Access Compliance Report Public Rights-of-Way (Curb Ramps)

Main Street: YORBA_ST **Cross Street:** E_ROMELLE_AVE **Location:** NE

ADA ID: RPRK220126121408 **Ramp Type:** Type 1 - Perpendicular Diagonal Initial Pass/Fail: Fail **Overall Compliance:** No **Severity Score:** 15

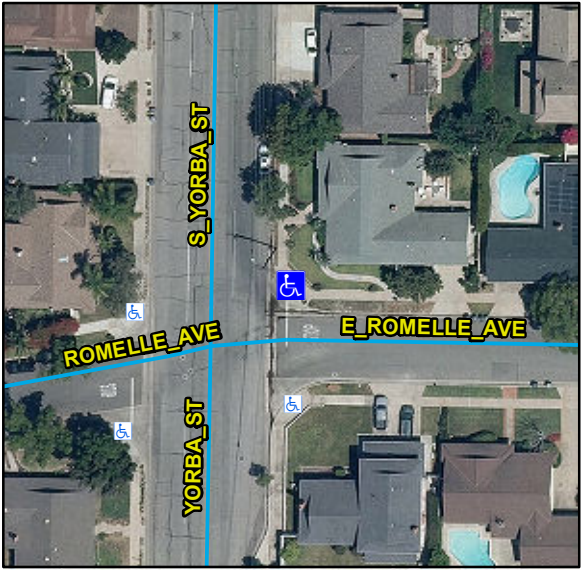
| Compliance | Description | Data | Compliance | Description | Data |
|------------|--|------|------------|-------------------------------|------|
| No | Ramp Run Slope (%) | 10.8 | N/A | Flare Slope LT (%) | N/A |

Possible Solutions:
Remove & Replace Curb Ramp With Two New Directional Ramps or Equivalent.

OC Std/PROW:
 R304.2.2, STD 1115
